Work Order ID 135094

Item Name: Crosstube Turning Detail

DRAWING NO. D206-667-141	TITLE CROSSTUBE ASS'Y (206B HIGH FWD)	REV. C	DART AEROSPACE LTD ENGINEERING ORDER		D.E.O. NO. D206-667-141-C-1	SHEET NO. SHEET 1 OF 1	SCALE NTS
DRAWN <i>JP</i>	CHECKED <i>ASS</i>	MFG. APPR. <i>JD</i>	APPROVED <i>WD</i>		DE APPR. <i>JA</i>		
DATE 11.07.15	DATE 11.07.20	DATE 11.07.21	DATE 11/07/21		DATE 11.07.21

DRAWING NO. D206-667-141		TITLE CROSSTUBE ASS'Y (206B HIGH FWD)		REV. C	DART AEROSPACE LTD ENGINEERING ORDER		D.E.O. NO. D206-667-141-C-2	SHEET NO. SHEET 1 OF 1	SCALE NTS
DRAWN AJS		CHECKED		MFG. APPR. <i>E</i>		APPROVED <i>RP</i>		DE APPR. <i>HA</i>	
DATE 12.08.02		DATE 12.08.02		DATE 12.08.02		DATE 12.08.02		DATE 12.08.02

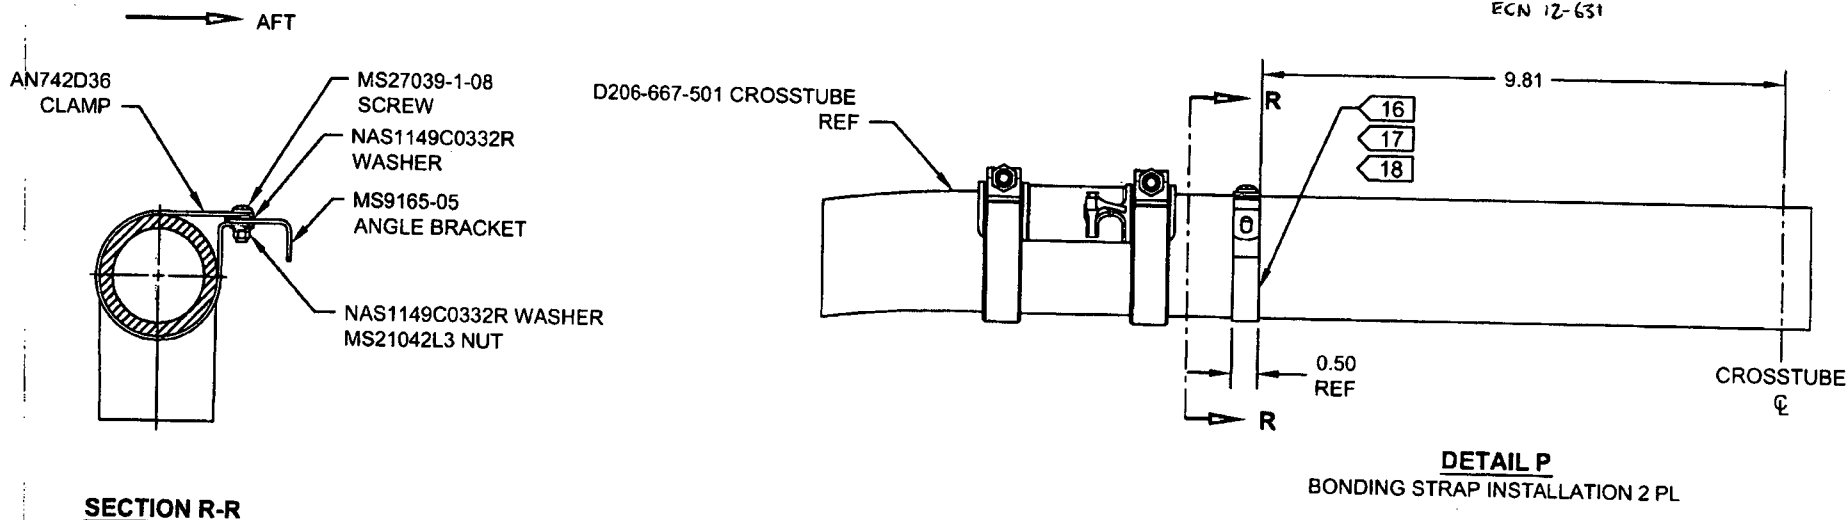
ADD ELECTRICAL GROUNDING STRAP

ITEM	QTY -141	PART NUMBER	DESCRIPTION
1	X	D206-667-141	CROSSTUBE ASSEMBLY (206B HIGH FWD)
10	2	AN742D36	CLAMP
11	2	MS9165-05	ANGLE BRACKET
12	2	MS21042L3	NUT (OR MS21042-3)
13	2	MS27039-1-08	SCREW
14	4	NAS1149C0332R	WASHER (OR AN960C10L)

- 16) MASK AREA UNDER CLAMP PRIOR TO PAINTING
- 17) SEAL EDGES WHERE AN742D36 CLAMP MEETS WITH THE CROSSTUBE USING SIKAFLEX-241/-291 OR MIL-S-8802 CLASS B2 OR PROSEAL 890 SEALANT
- 18) PERFORM RESISTANCE CHECK TO ENSURE MAX RESISTANCE IS 10 MILLIOHMS
